**South and West Plans Panel, Thursday 9 June 2022, planning application 21/07156/RM (Item 8)**

At the South and West Plans Panel meeting on Thursday, you will be considering Agenda Item 8, planning application 21/07156/RM, the reserved matters application for the erection of 289 dwellings with access within the site, garaging, parking, landscaping and public open space. In April 2022, the application was deferred subject to further information being submitted by the Applicant, Redrow. The proposal is located in the village of West Ardsley, south-west of Leeds.

In the adopted Site Allocations Plan (SAP) (July 2019), the site forms part of the larger allocated sites HG2-168 and HG2-169 shown below (extracts taken from SAP Section 3).

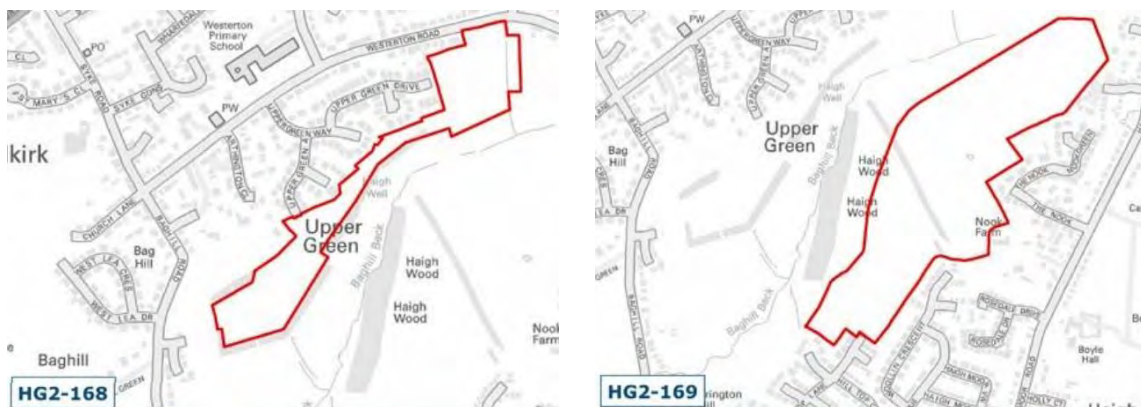
SAP allocated site HG2-168 includes the area which now separates Parcels A and B and would have enabled two linked accesses on to Westerton Road. This loop would have reduced the lengths of cul-de-sacs in the existing Upper Green residential area and for the proposed houses in Parcel A. It would also have allowed vehicles to avoid the severe congestion at the junction of Upper Green Way and Westerton Road due to a nearby primary school. These issues have been raised by WAAG and residents in their objections. Without this connection, Parcel A will have cul-de-sacs more than double the maximum SPD length and will force traffic from the 54 proposed houses to use the Upper Green Way/Westerton Road junction thereby, worsening the severe congestion around the main school entrance. The Chief Planning Officer's report does not explain how Parcel A is compliant with the SPD in light of the excessive length of the cul-de-sacs (paragraph 30). Safety assurances in the same report are not supported by the traffic issues we have set out (paragraph 34).

**Figure 1 - Analysis of the Haigh Wood Development to LCC Design Guidance**

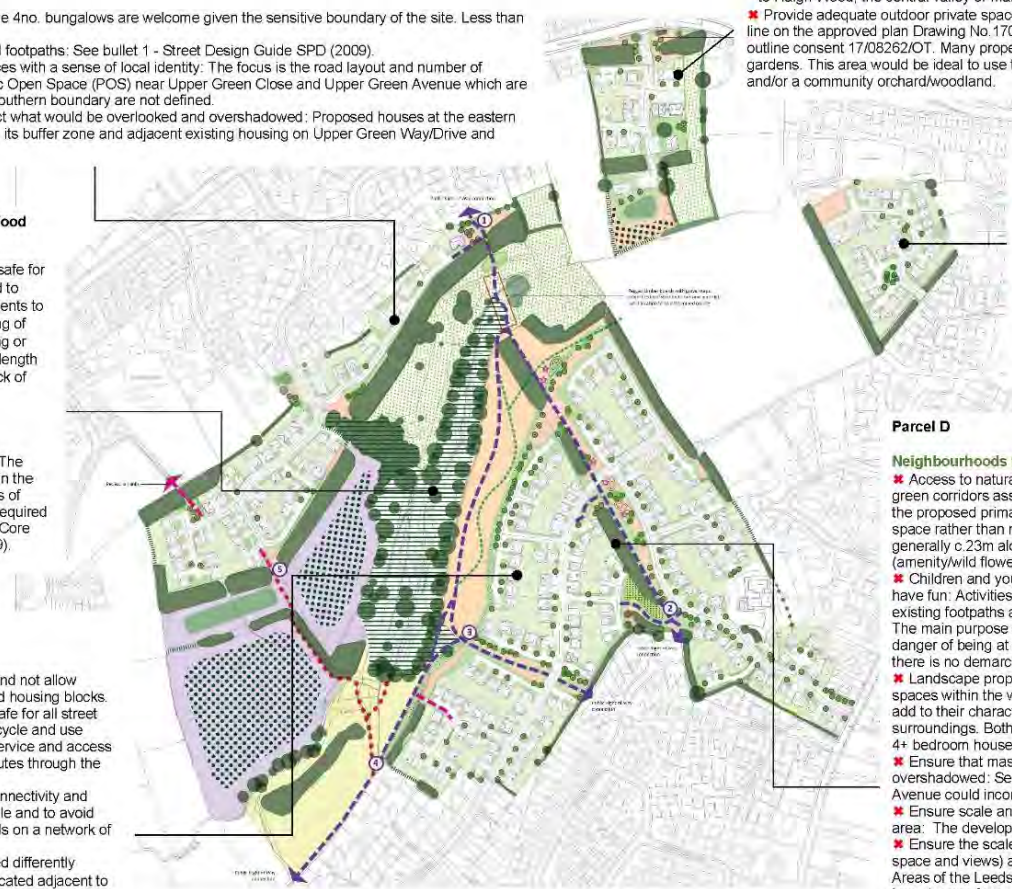
- ★ The layout should create an environment that is safe for all street users and in which people are encouraged to walk, cycle and use public transport: The improvements to the footpath network primarily relate to the upgrading of existing definitive routes. No footpaths either existing or new are suitable for cyclists. The increased overall length of the footpath network is minimal plus there is a lack of connection for Parcels B and C.

- ★ The site should be related to its neighbourhood: The Applicant has not considered existing green space in the Ardsley & Robin Hood/Morley South Wards in terms of deficits and surpluses or quality standards. This is required to be compliant with key Policies G3 and G4 of the Core Strategy (Adopted 2014 and Selective Review 2019).
